External Design Document Suitability Review Checklist

Title: **Site Specific PMP and Ancillary Meteorological Analysis**

Number: **180461.51.1011**

DOCUMENT NUMBER/ TITLE: 180461.51.1011 - PINGP Site Specific PMP and Ancillary Meteorological Analysis

Figure 14. 24-hour all-season Depth-Area curves at the PINGP basin centroid

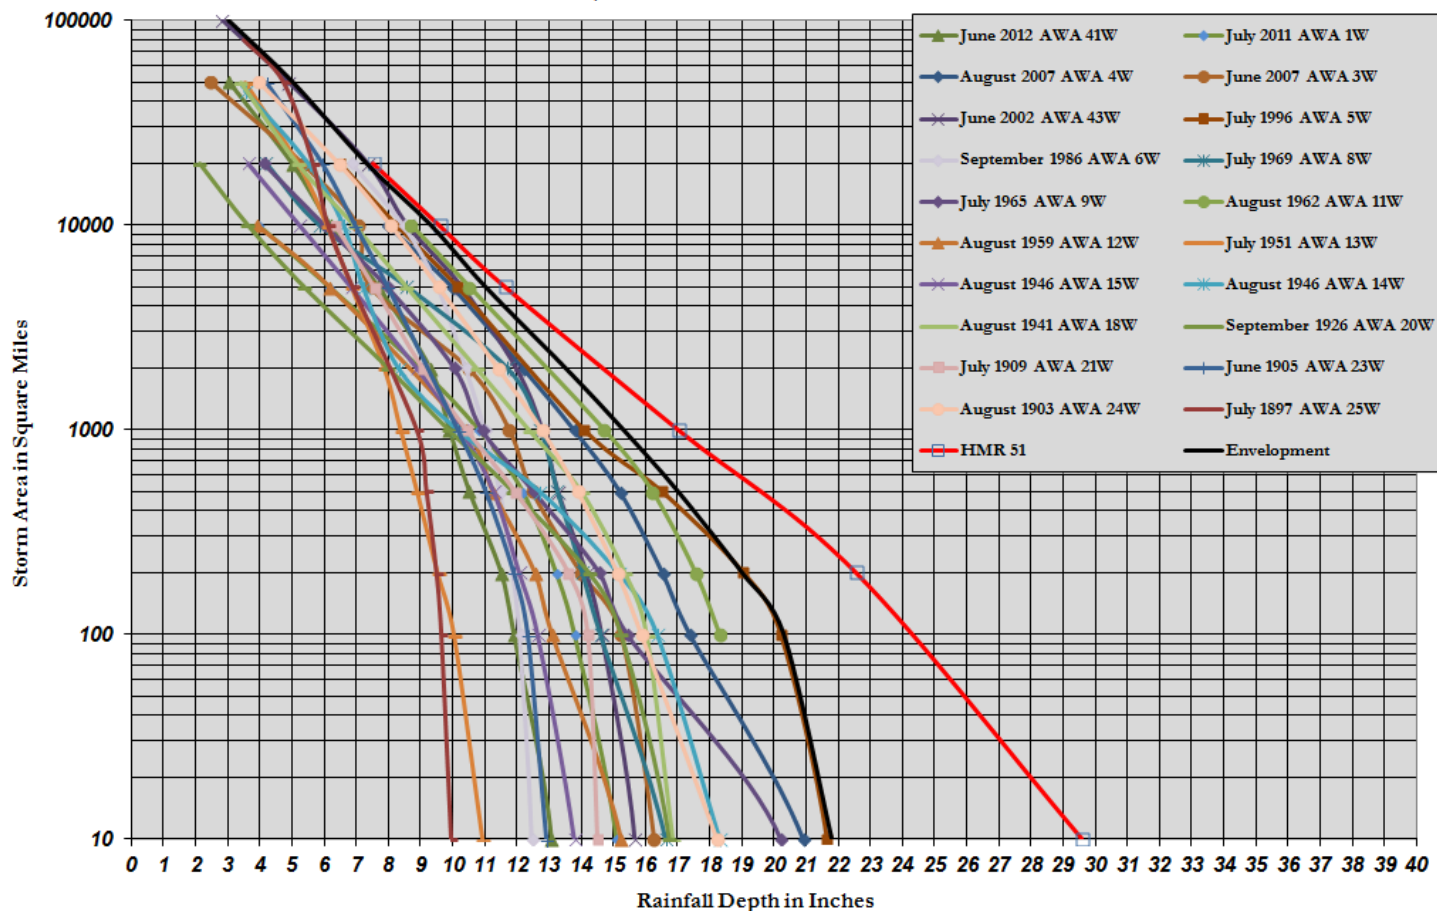
Design Review Comment Form	
11	<p>14 (and, if necessary, other parts of the calculation) with Attachment 7.</p> <p>Also regarding Figure 14 on page 45: Figure 14 still does not list Storm 22W, as Aterra noted. The storms listed in Attachment 7 do not include Storm 22W either. Please mention Storm 22W in the calculation as appropriate.</p>		
Reviewer: Bill Partridge Date: 16MAR15		Preparer:  Date: 03-16-2015
